Technical Service Bulletin

SUBJECT:
No Restart/Rough Idle
After A Hot Soak

NO: 18-09-98 Rev. B
GROUP: Vehicle Performance
DATE: Jun. 12, 1998

THIS BULLETIN SUPERSEDES TECHNICAL SERVICE BULLETIN 18-09-98 REV. A, DATED MAR. 13, 1998, WHICH SHOULD BE REMOVED FROM YOUR FILES. ALL REVISIONS ARE HIGHLIGHTED WITH **ASTERISKS**** AND INCLUDES NEW SOFTWARE FOR ALL APPLICATIONS, THE ADDITION OF THE 3.5L ENGINE, AND ADDED PROCEDURES FOR THE 2.7L ENGINE.**

FIGURE 4

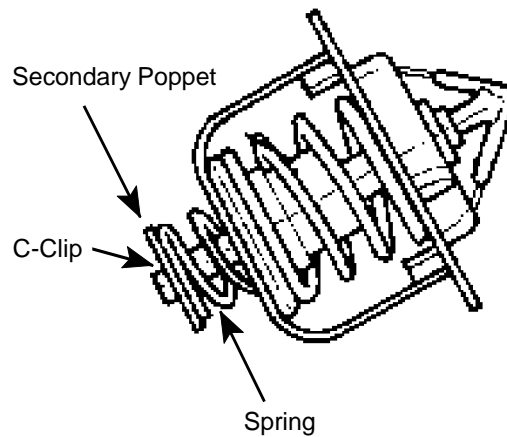
2. Press down on the secondary poppet spring. Remove and discard the secondary poppet c-clip, and spring (Figure 4).

FIGURE 5

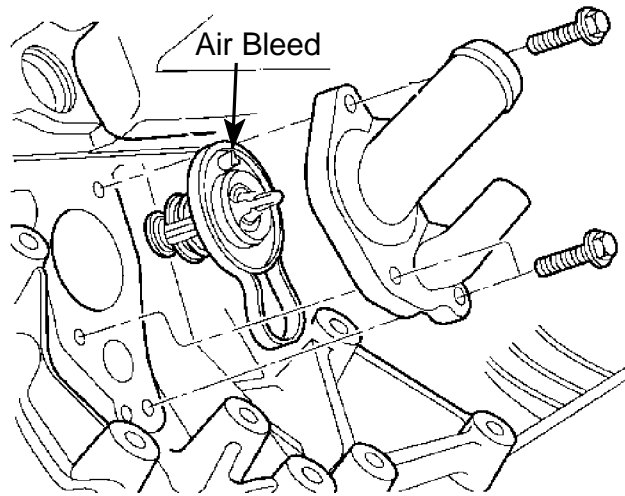
NOTE: THE THERMOSTAT AIR BLEED MUST BE AT THE 12:00 O-CLOCK POSITION (FIGURE 5).

FIGURE 6

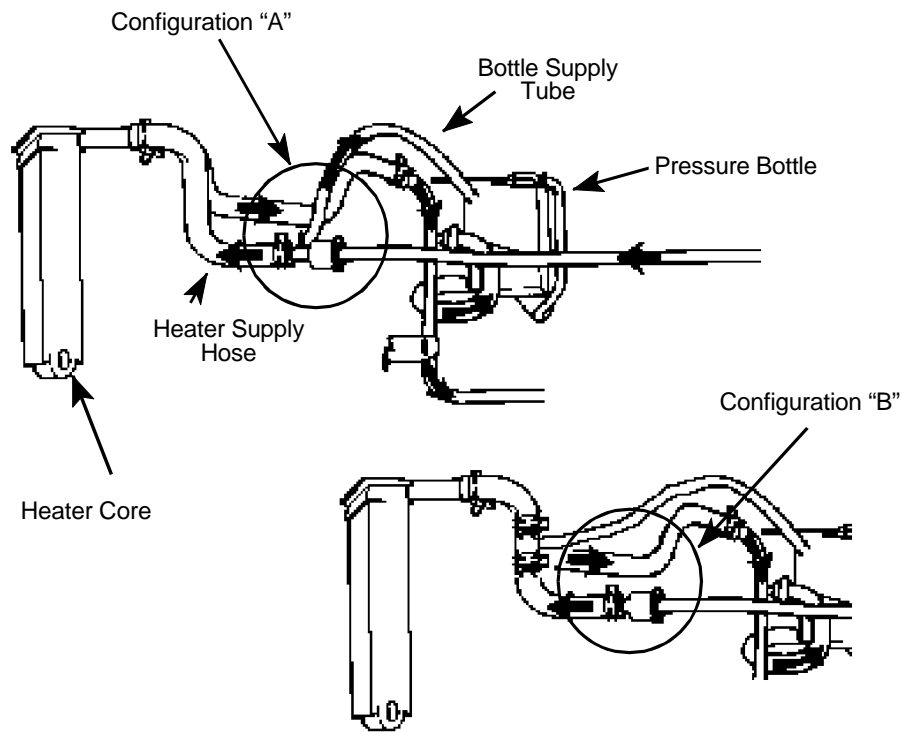
4. Identify the heater supply hose (Figure 6).

5. If the heater supply hose is configured as shown in Figure 6 "A", obtain p/n's heater supply hose 04596346AA, heater supply hose 04767170AB, four hose clamps 06502018 and two hose clamps 04592126. If the heater supply hose is configured as shown in Figure 6 "B", obtain p/n's heater supply hose 04767170AB, four hose clamps 06502018 and two hose clamps 04592126.

6. For configuration "A", remove and discard the existing heater supply hose.

8. For configuration "B", leave the quick connect attached to the heater supply tube and remove and discard the rest of the supply hose assembly.

FIGURE 7

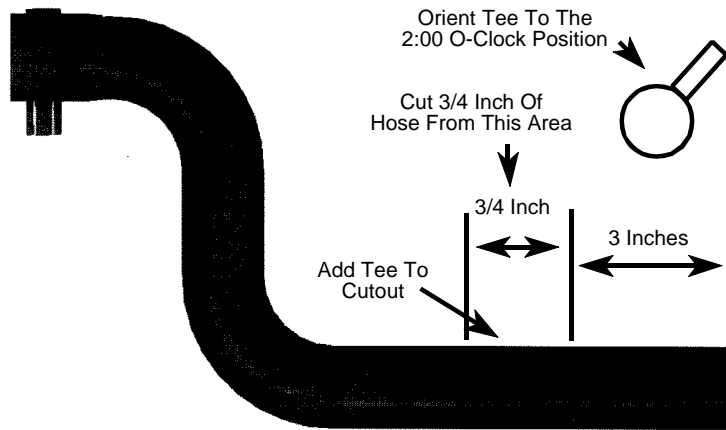
9. For both configurations, cut the new hose p/n 04767170AB as shown in Figure 7.

10. For both configurations, insert the Tee into the cut section of the heater hose. Use two hose clamps p/n 06502018 to complete the assembly. Before tightening the clamps, orient the Tee to the 2:00 O-Clock position as viewed from the front of the vehicle (Figure 7).
 11. Install one end of the 3/8 inch hose onto the Tee using hose clamp p/n 04592126.
 12. Install the heater hose onto the heater supply tube and heater core. Use clamps p/n 06502018 to secure both ends.
- 18-09-98 Rev. B -8-
13. Install the remaining end of the 3/8 inch hose to the coolant pressure bottle. Use clamp p/n 04592126. The final heater hose configuration is shown in Figure 8.
